Access Compliance Report Public Rights-of-Way (Curb Ramps)

Main Street: FOSTER_RD Cross Street: TIGERTAIL_DR Location: NE

ADA ID: RPRK211207125926 Ramp Type: Type 1 - Perpendicular Diagonal Initial Pass/Fail: Pass Overall Compliance: No Severity Score: 0

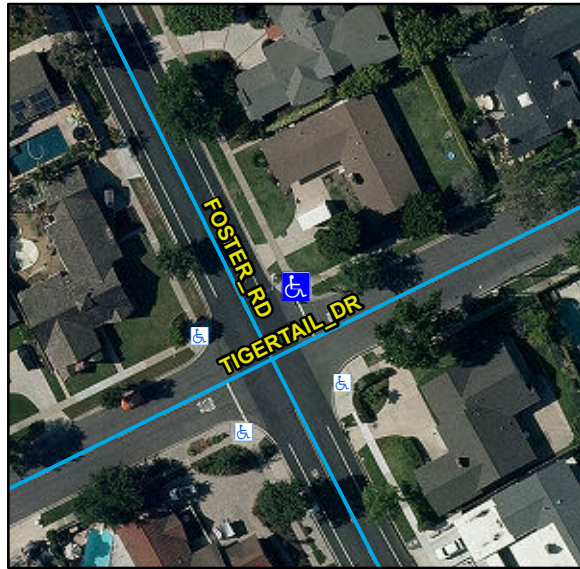
N/A	Ramp Inside Crosswalk 1	N/A	Yes	Ramp Inside Crosswalk 2	N/A
	Crossing 1 Slope (%)	7.6		Crossing 2 Slope (%)	3
	Crossing 1 Cross Slope (%)	4.3		Crossing 2 Cross Slope (%)	1.3
No	Gutter Ponding	Yes	Yes	Curb Slope	2.7
Yes	Gutter Lip Height (in)	0		Road Run Slope (%)	1.3
Yes	Gutter Run Slope (%)	5		Road Cross Slope (%)	5.7
No	Gutter Cross Slope (%)	2.8			
Yes	Overall Surface Condition: Acceptable		Yes	Perp Joint Present	Yes
	Cross Gutter Present?	No		Spandrel Present?	No
	Replace Cross Gutter?	N/A		Replace Spandrel?	N/A

Remove & Replace Gutter.
